Sent: 6/7/2021 9:29:18 AM
Subject: FW: O8W-PM 35217268, 35224712, 35224713 - Bucks Creek 1101 Phase 1,2&3 - Pre-Engineering Meeting

Subject: O8W-PM 35217268, 35224712, 35224713 - Bucks Creek 1101 Phase 1,2&3 - Pre-Engineering Meeting

PM 35217268 (Phase 1)

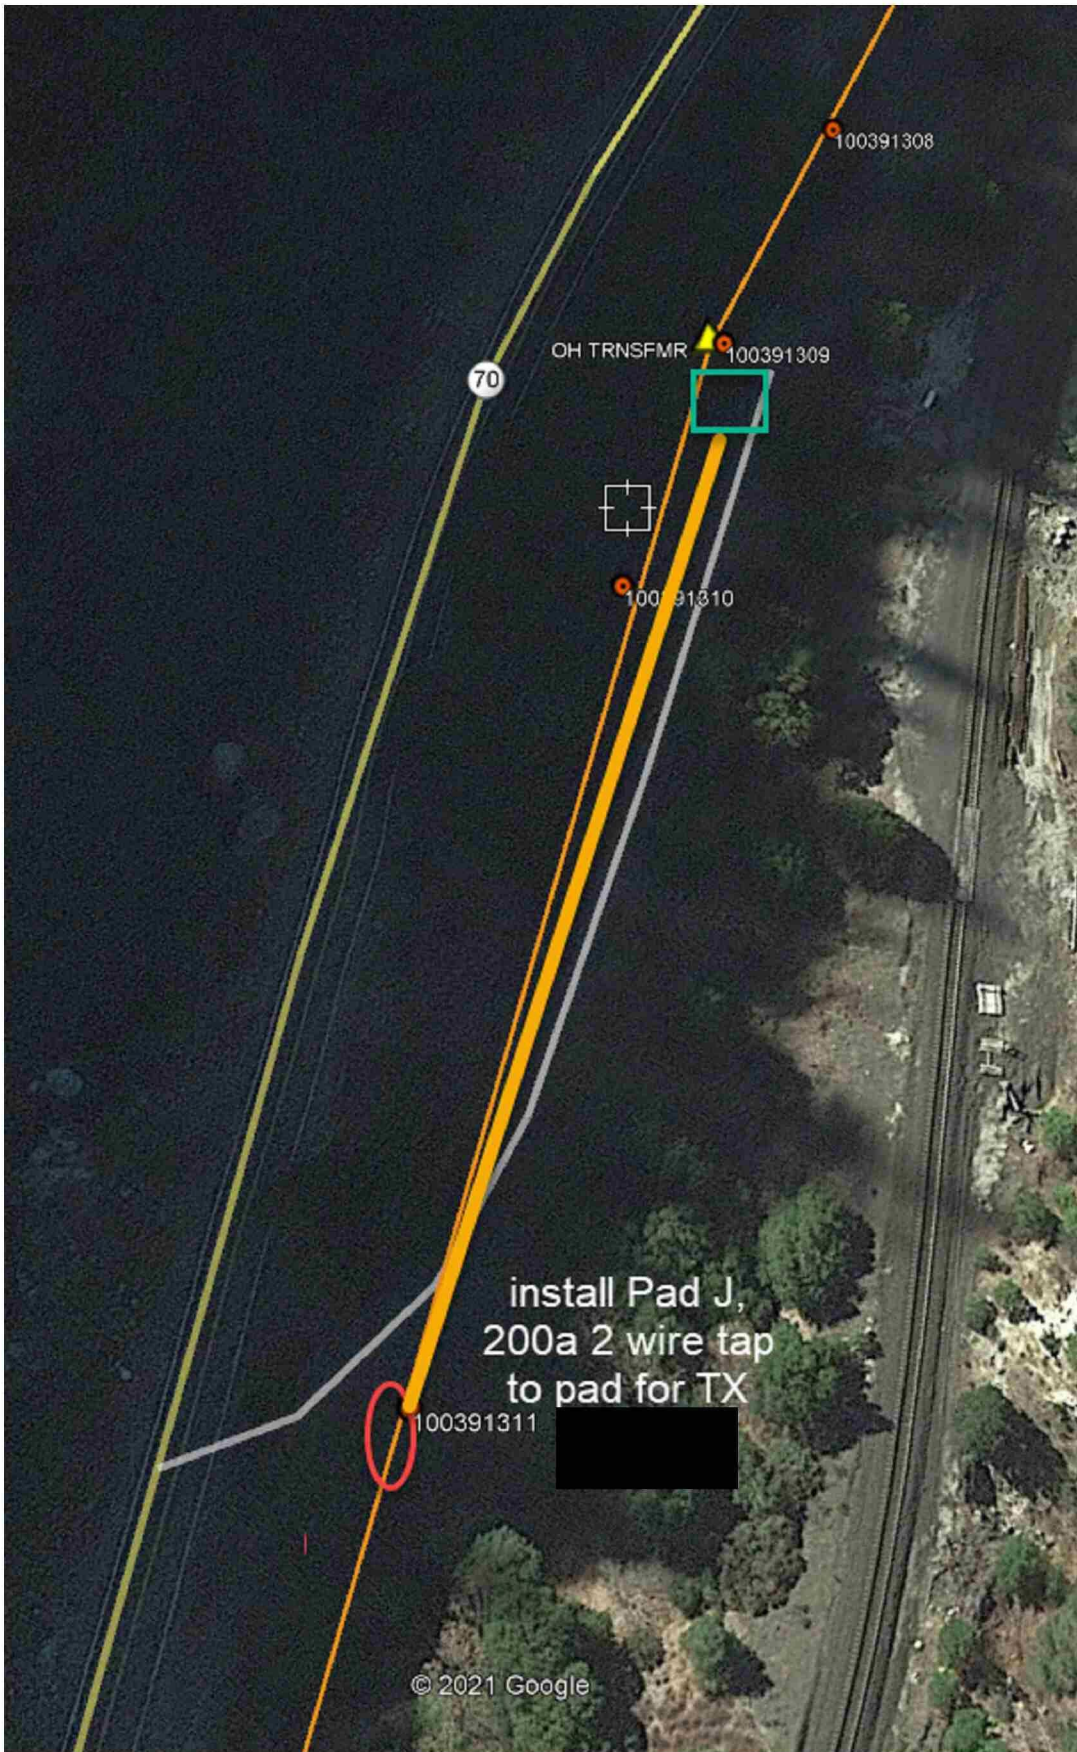
Your outlet red-line Bucks Creek looks close to what I was thinking. Need to work with [REDACTED] to get this designed with a single 6" and use #5 boxes with 200A cable. There is not a reason this will need (2) 6" and 1-4" and 7 boxes. There is probably only 20a peak on the primary now.

Before we involve Cal T and [REDACTED] it would be good to scope with the estimator so we can address the local folks with a somewhat solid plan. If we can establish the outlet for Bucks Creek Sub + the TX locations for Cresta Dam and [REDACTED] that should take most of the questions away. Rock Creek Bridge is the only thing I saw a big issue with. The local guys can help us once we determine what we are doing and make sure we get the details correct for permit.

Also need to see what Hydro is willing to do with the TX for the penstock metering valve at Rock Creek PH. It will be a long way up from the

Need to see if Hydro has GPR data for the Hwy 70 road bed to see if we can get 42" minimum cover and keep clearance over any hydro facilities.
